**AGENDA OF THE CITY COUNCIL MEETING
FOR THE CITY OF HAYDEN, KOOTENAI COUNTY, IDAHO**

Agenda Item: Authorize Change Order No. 5 with LaRiviere, Inc. for the Honeysuckle Avenue and Ramsey Road Roundabout Project for changes related to private utility delays and conflicts, pedestrian access revisions, a deductive adjustment for water facility testing, a deductive adjustment for resident project representative costs for Saturday work, and a time adjustment to ensure that added contract days fall on working days for a net cost decrease of \$6,108.43 and twelve (12) added contract days.

CONTRACT CHANGE ORDER NO. 5

CONTRACT CHANGE ORDER NO. 5
TO
41014.14 - HONEYSUCKLE AVENUE AND RAMSEY ROAD ROUNDABOUT IMPROVEMENTS

WORK CHANGE DIRECTIVE NUMBER: 10

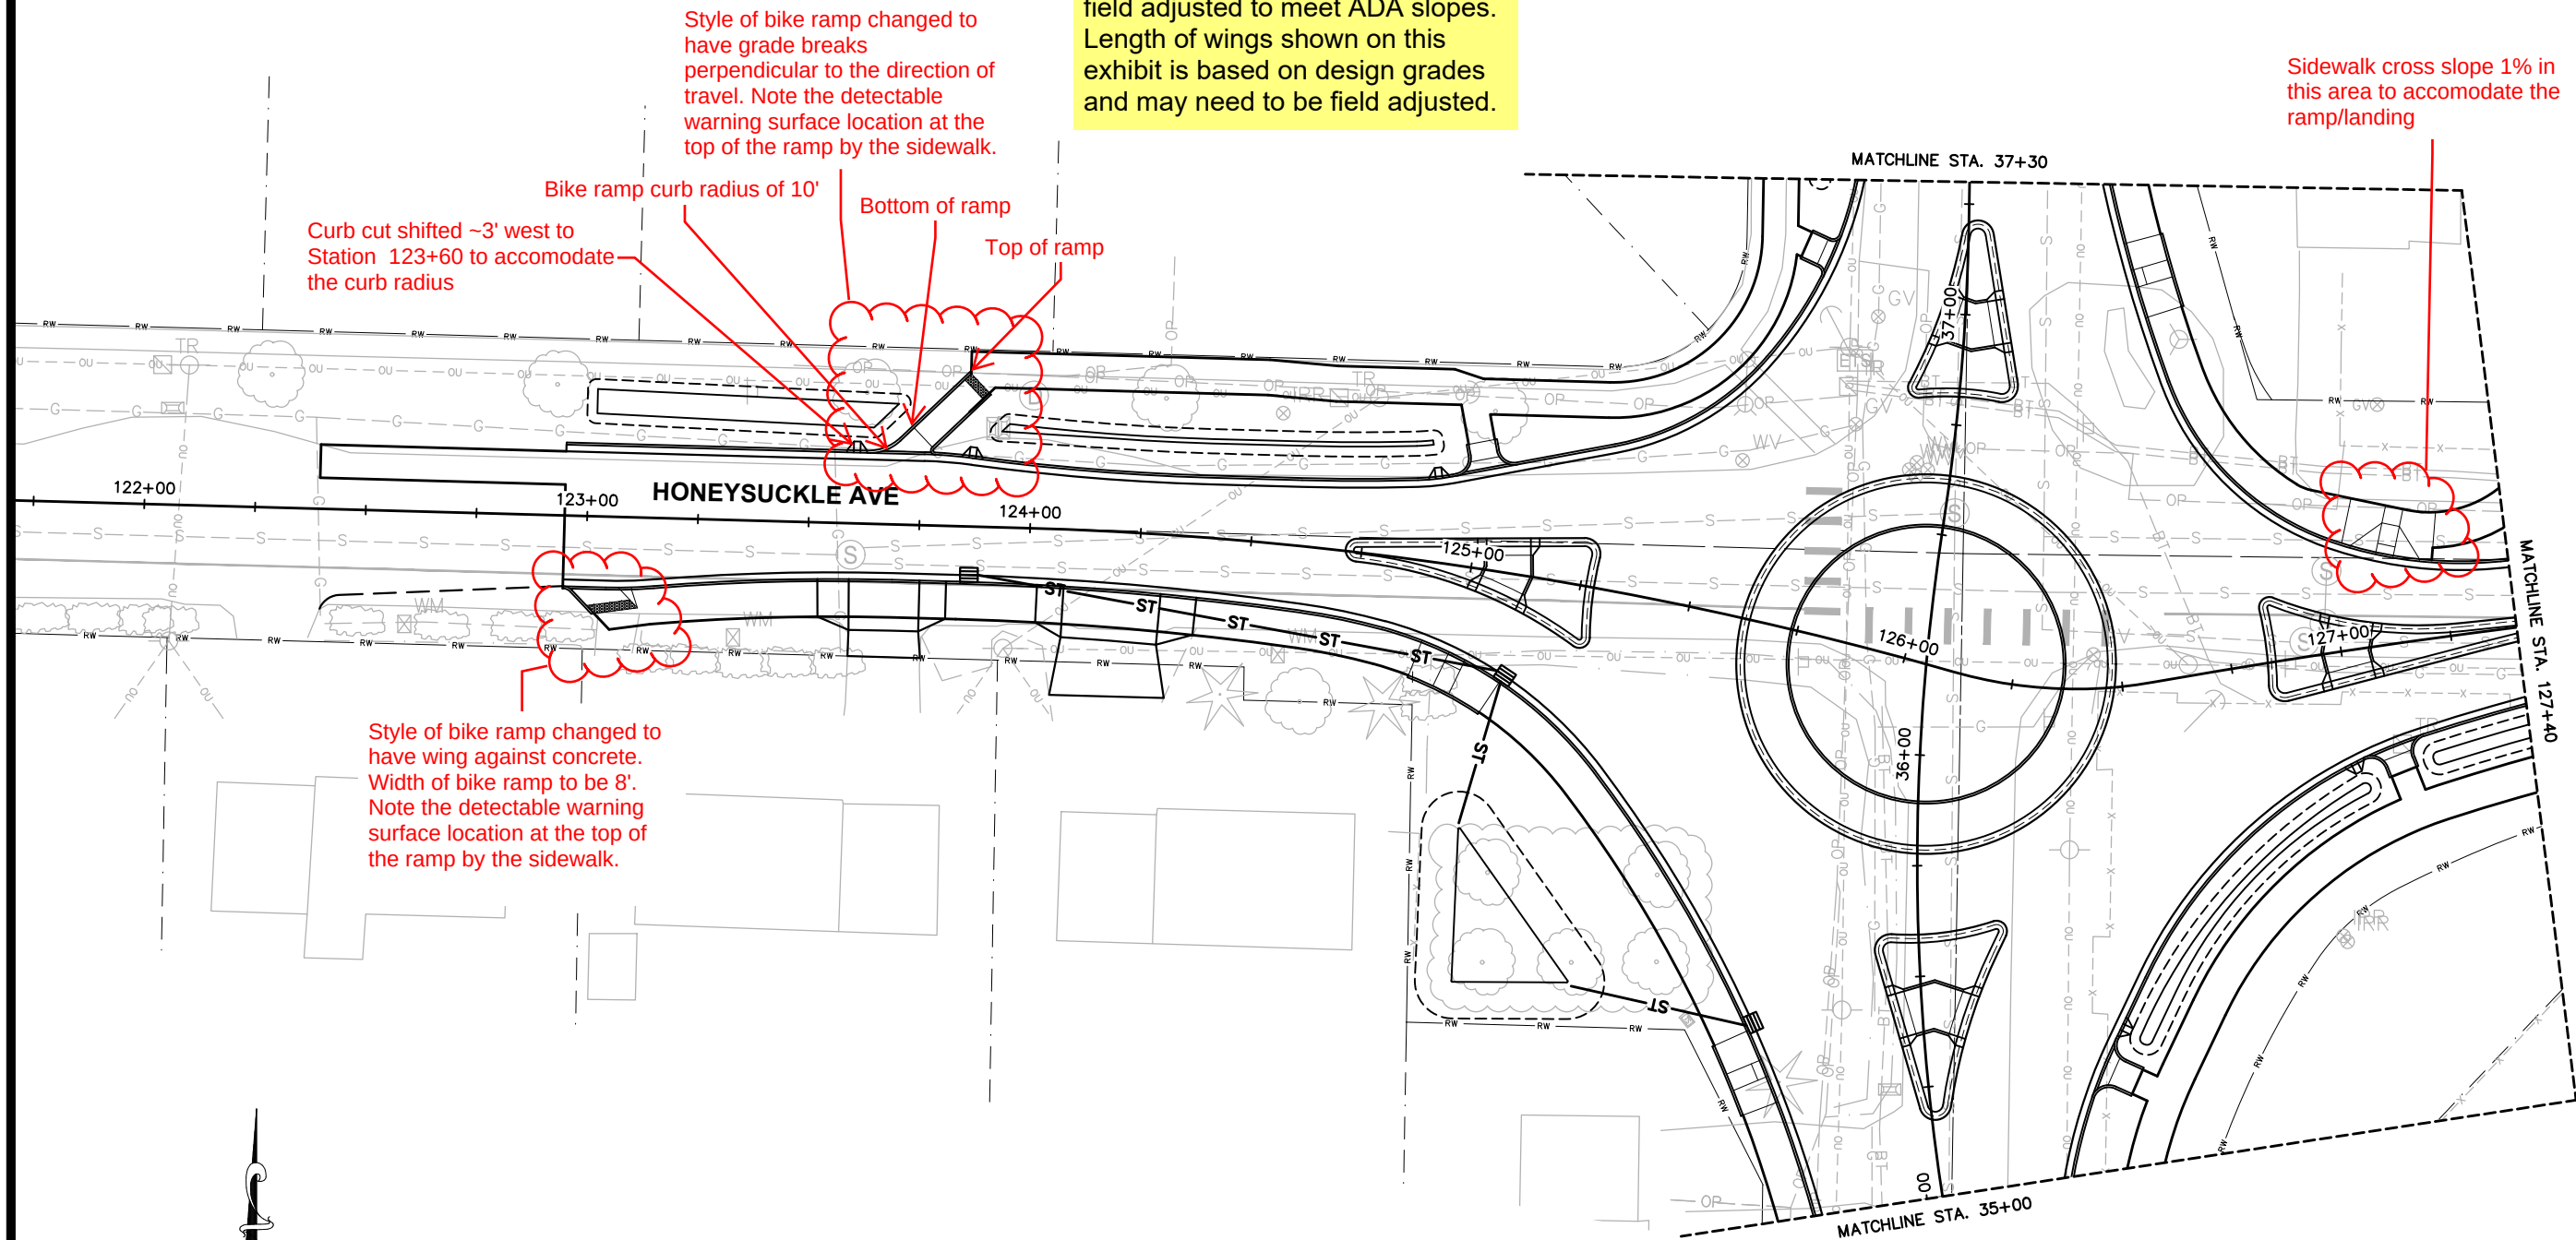
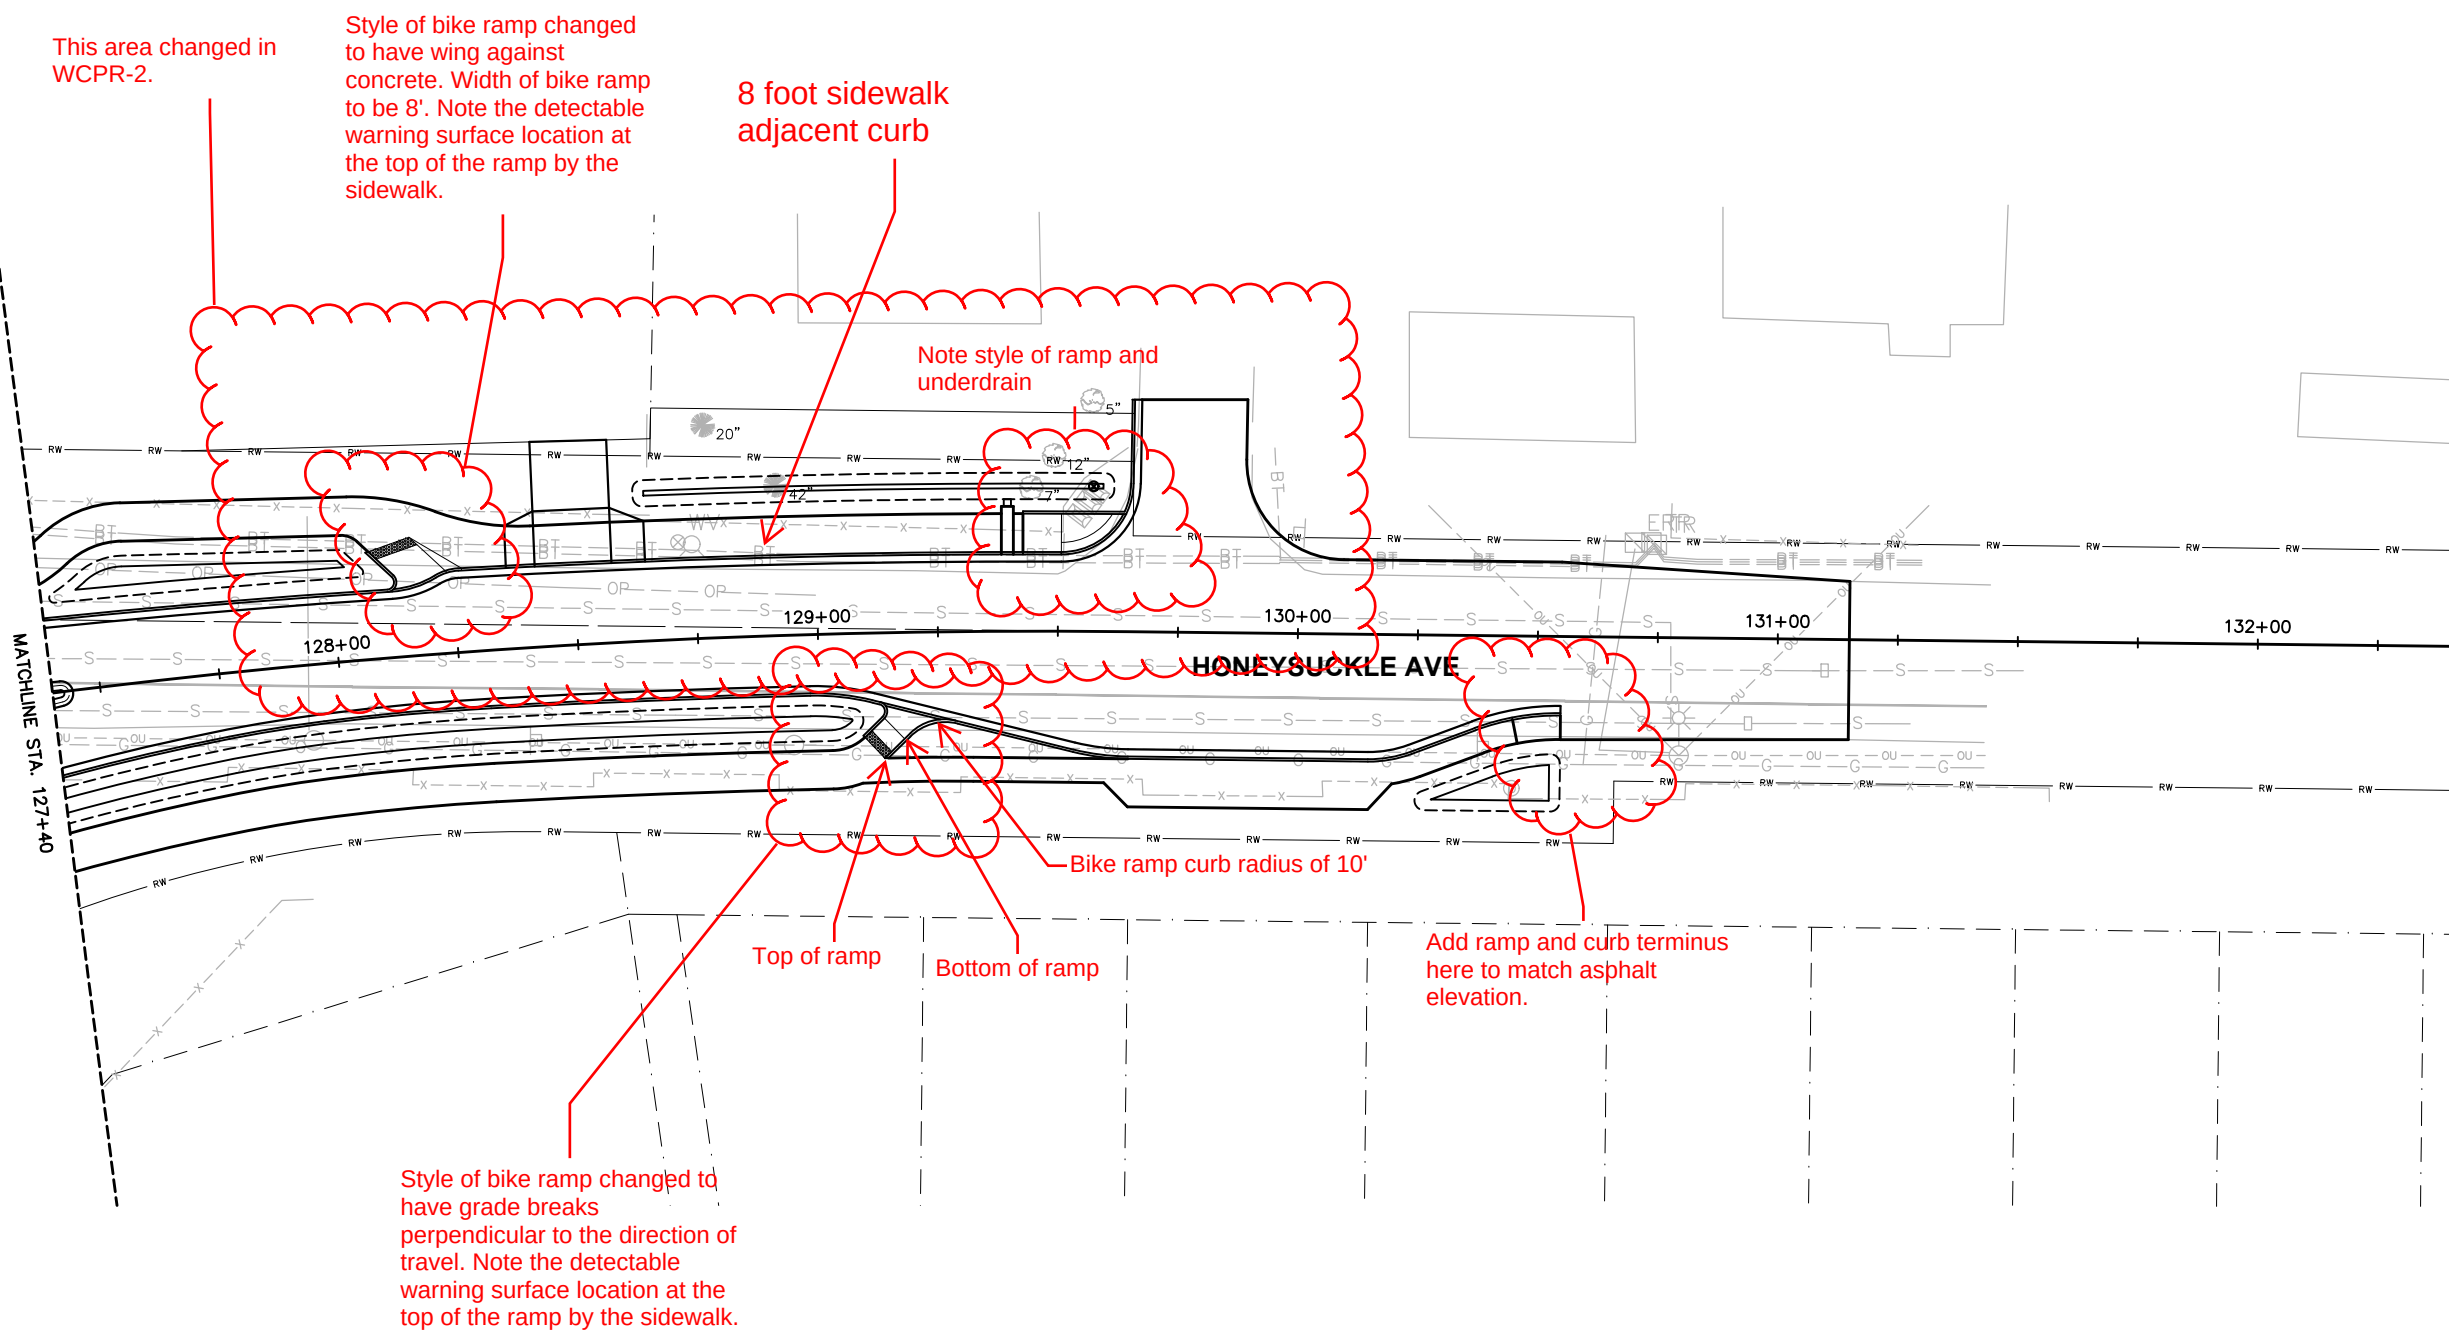
Refer to attached exhibits for modifications to ped ramp style, approach style, and adjustments to sidewalk. Any adjustments to quantities will be noted and paid at unit cost.

- Honeysuckle/Ramsey Intersection Plan View Exhibits (Four Sheets – West, East, South, and North Leg)
- Bike Ramp Detail
